Bridge Preliminary Design Report

**Ramp B over Fairground Rd.
SCI-823-1593**

**SCI-823-10.13
PID No. 79977**

- ODOT Review Comments to Structure Type Study with Consultant Responses

PLAN
* 31'-6" PROVIDED TO PERMIT FUTURE 12'-0" LANE

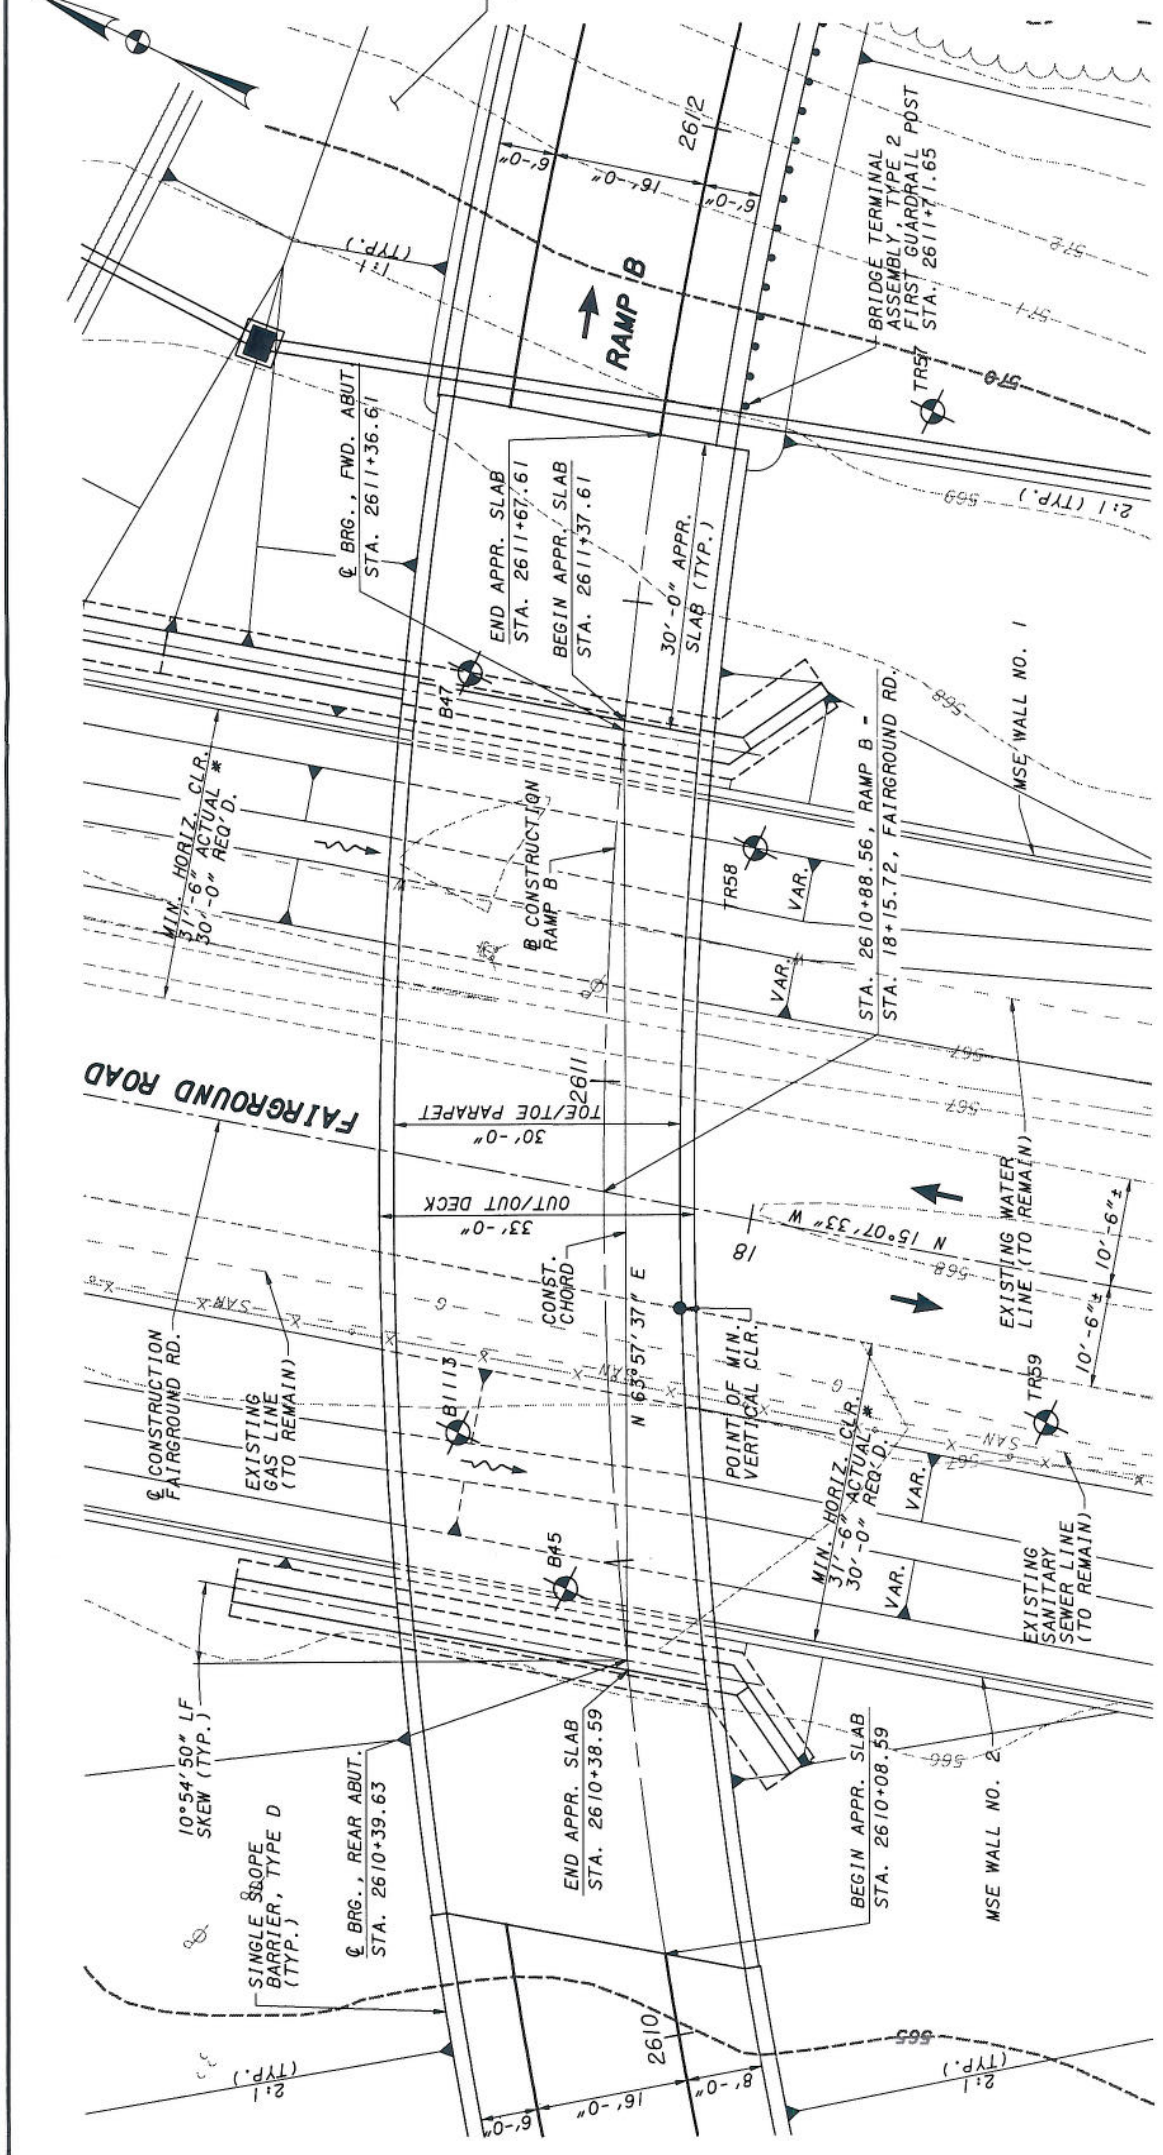
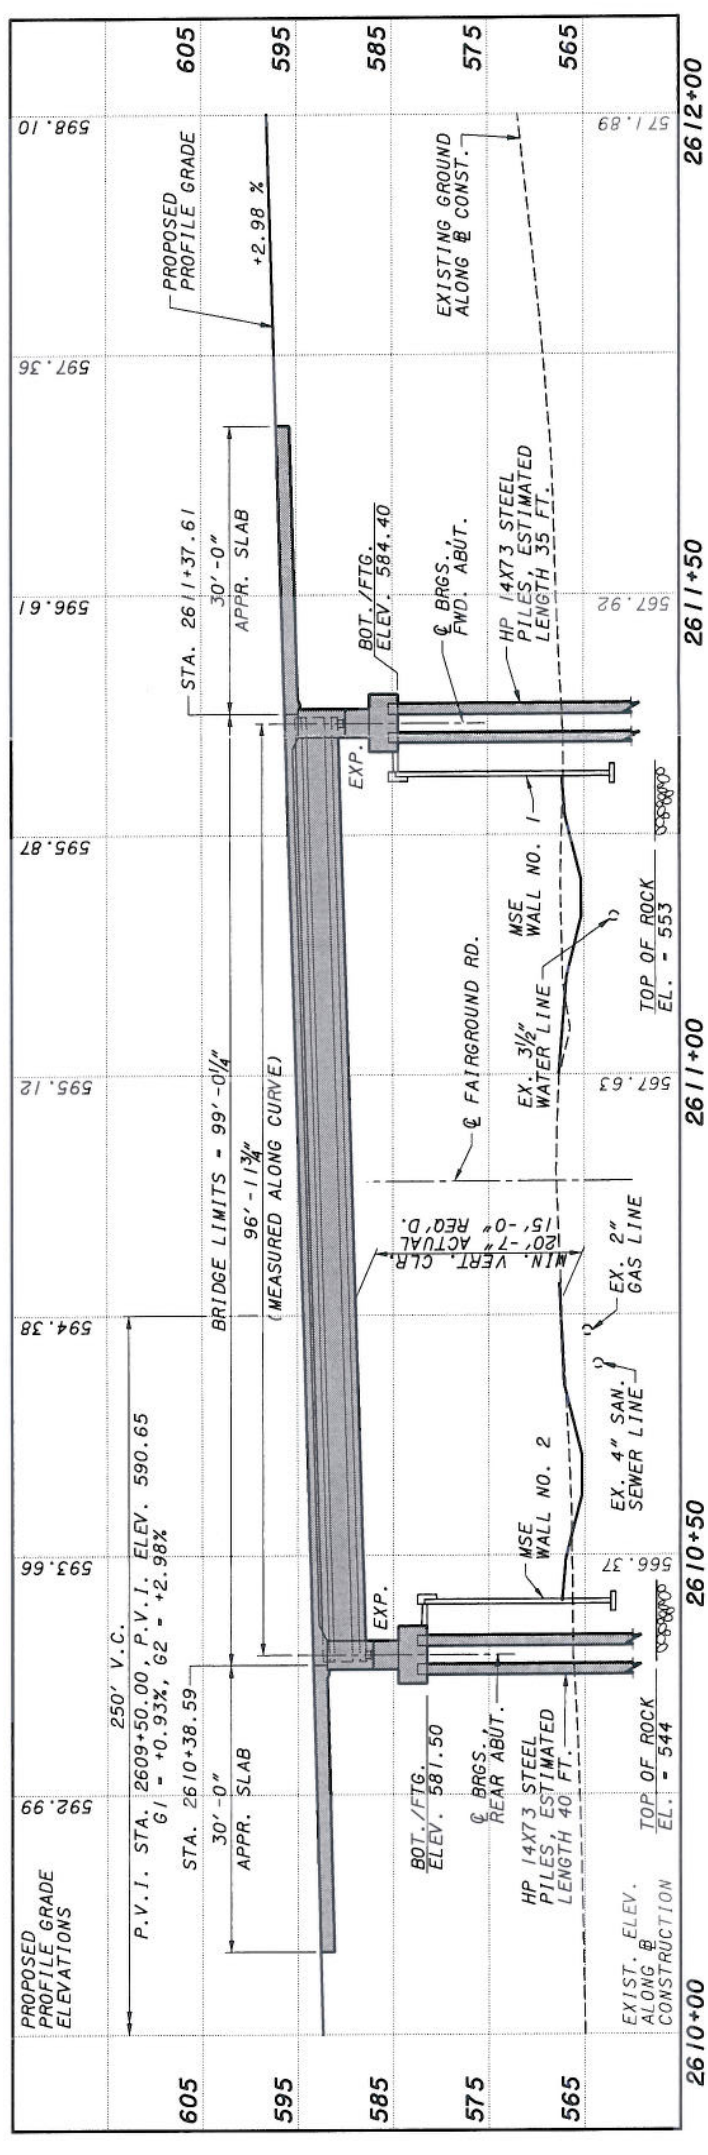
<p>Site Plan (1/3)</p>	<p>5. We could not verify the 30'-0" proposed horizontal clearance after referring to ODOT's L&D Manual, Volume 1, Fig. 600-1. Please make sure that approval of horizontal clearance is obtained from ODOT - Office of Roadway Engineering Services prior to proceeding.</p>	<p>See attached documentation pertaining to design/posted speed and design year ADT along Fairground Road to justify the required 30'-0" clear zone distance to the MSE walls. Since the PAVR submittal, CH2M HILL has had discussions with the Scioto County Engineer's Office. The county stated that Fairground Road will be improved to 2-12' lanes and that the speed limit is 55 mph. With a design speed of 60 mph and an ADT greater than 3000 vpd, Fig 600-1E recommends a clear zone distance of 30'-0" when the ditch foreslope varies between 6:1 to 4:1. Due to additional culverts being added along Fairground Road, new ditches are being designed with foreslopes varying from 6:1 to 4:1; the steeper than 6:1 foreslope also provides the avoidance of utilities, while also using existing drainage structures. Providing lateral bridge clearance equal to the clear zone provides a safer roadway and allows for future improvements.</p>

TYPICAL TRANSVERSE SECTION

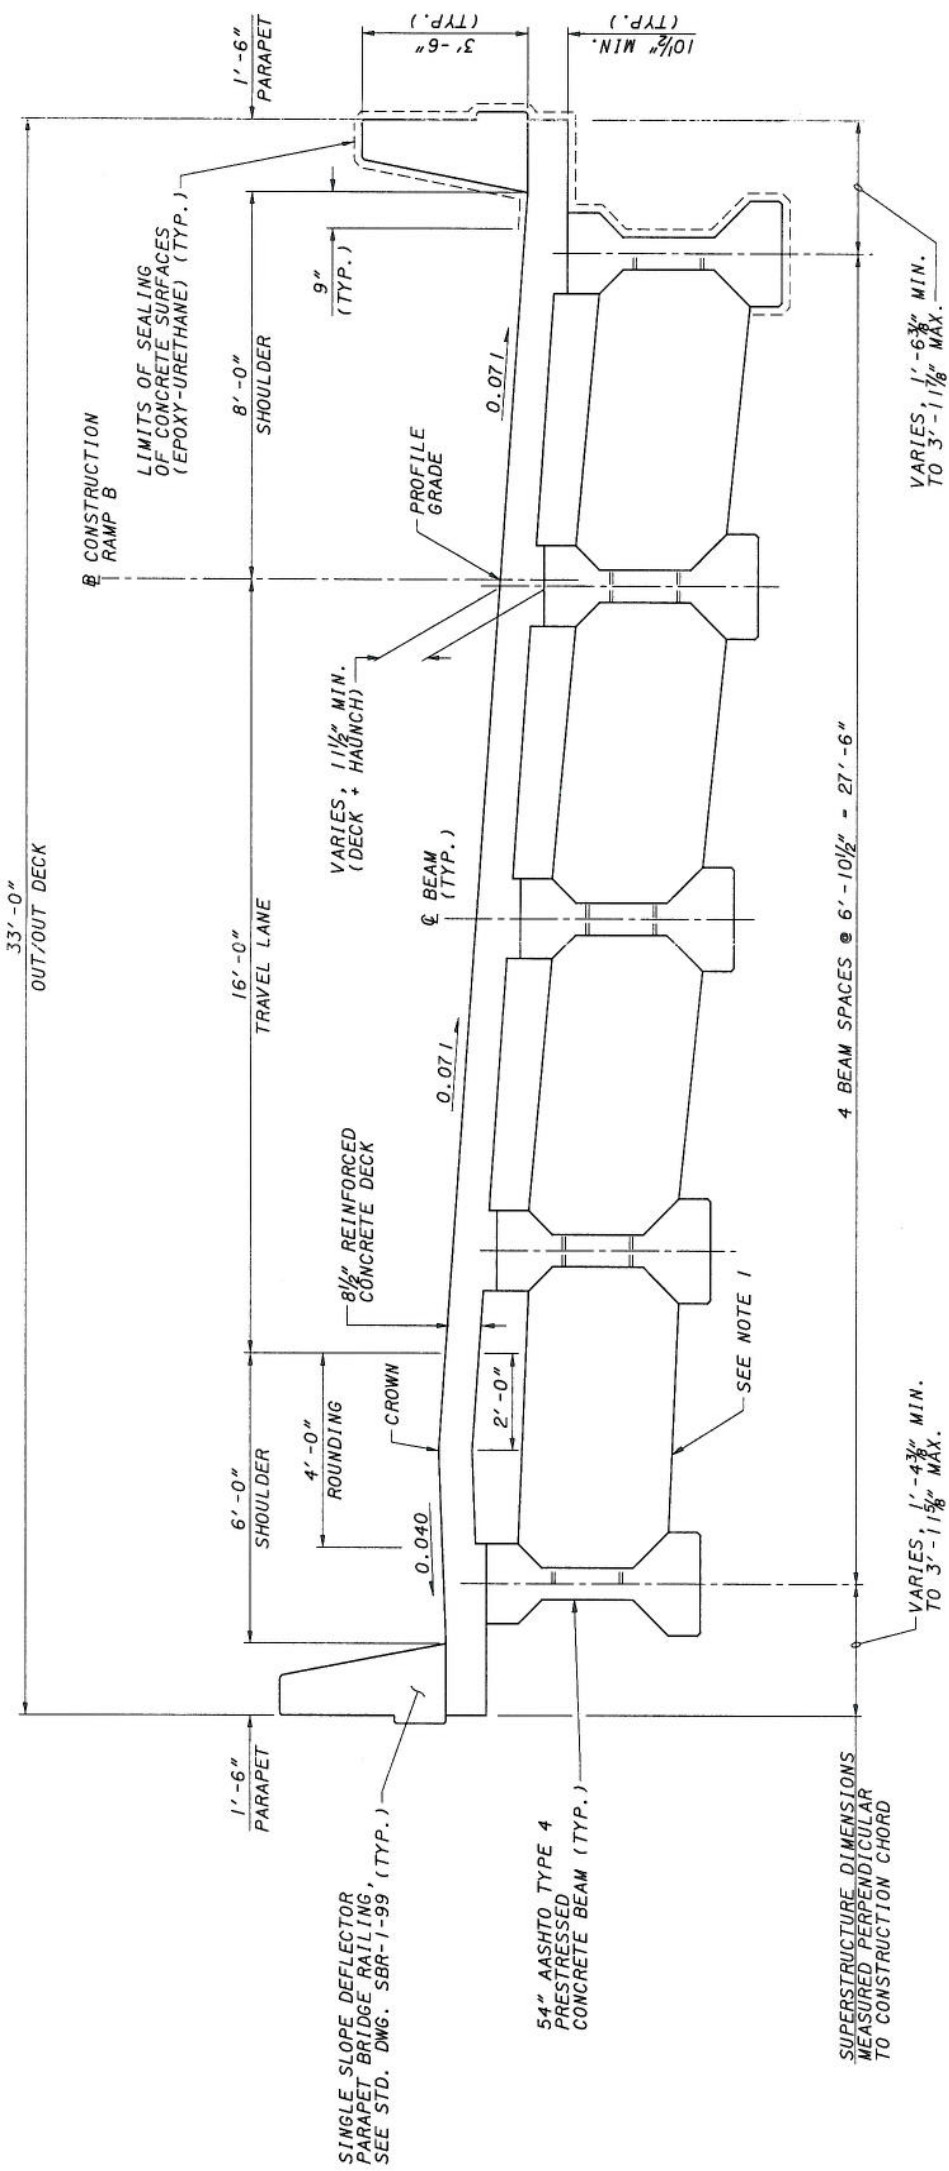
Transverse Section (2/3)	6. The superelevation rate at the proposed Ramp B is 7%, which corresponds to 35 mph Design Speed. What is the Design Speed of the northbound U.S.R. 23 at the proposed location? The proposed Ramp B will carry traffic exiting northbound U.S.R. 23 onto eastbound S.R. 823. Ramp B would preferably be designed with the same design speed as northbound U.S.R. 23. However, our office cannot comment on the alignment and profile grade, because the geometric review of the proposed alignment will need to be reviewed by the ODOT - Office of Roadway Engineering Services . Please make sure to obtain an approval from the ODOT - Office of Roadway Engineering Services prior to proceeding with the next design stage.	The design speed of the northbound U.S.R. 23 at the proposed location is currently 40 mph. Attached is an email from ODOT District 9 approving our geometric design of the interchange. Also attached is the Technical Memorandum explaining our geometric design of the interchange, which ODOT District 9 was provided.

Figure 1 - Soil Profile for MSE Wall 2

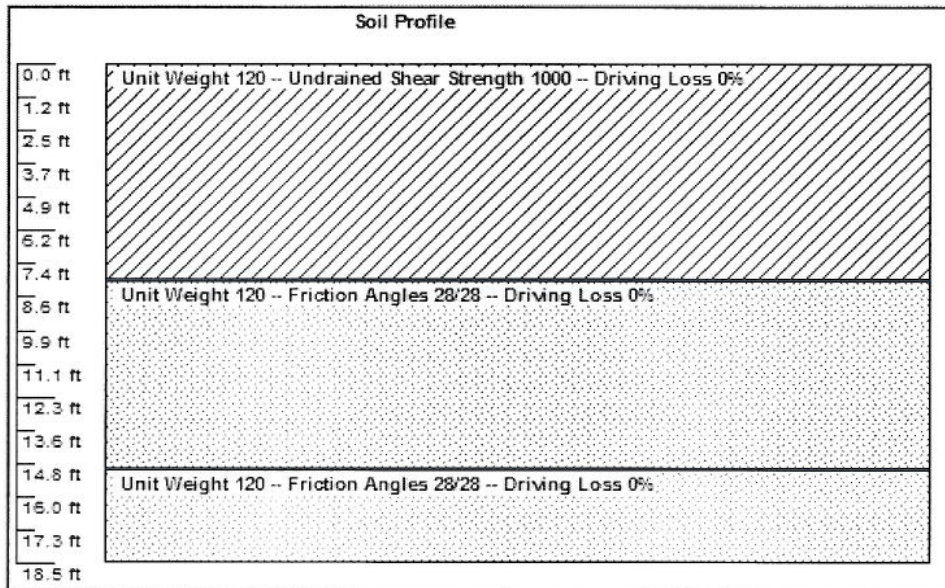
1. MSE Wall 2: The DLZ design computations in Appendix IV, page 1 of 21, show a geotechnical design profile as follows:
 - a. Ground surface of the boring (elevation 566-ft) to elevation 548-ft (18-ft below ground surface) is a silty clayey material with an undrained shear strength of $C = 1,500$ psf.
 - b. From elevation 548-ft down to elevation 544-ft (22-ft below ground surface) is a sandy material.
 - c. Top of Rock is encountered at elevation 544 (22-ft below the ground surface).
 - d. Water Table is encountered at elevation 550-ft = 16-ft below ground surface.

However, all the MSE Wall 2 borings show a predominately loose sand (79% sand and gravel) with an estimated friction angle of approximately 28-degree (based on N value corrected for overburden) at a depth of approximately 8-ft (elevation 558-ft). This layer extends down an additional 7-ft to elevation 551-ft. The "sand and gravel" layer encountered is a very loose to loose sandy gravel, also with an estimated friction angle of approximately 28-degrees. This layer extends to the top of rock (elevation 544-ft).

I would recommend re-evaluation of the borings for MSE Wall 2, and performing slope stability analysis using the profile depicted below in Figure 1. In particular, I recommend replacing the friction angle of the gravel sand at the rock interface with a more appropriate value of 28-degrees.
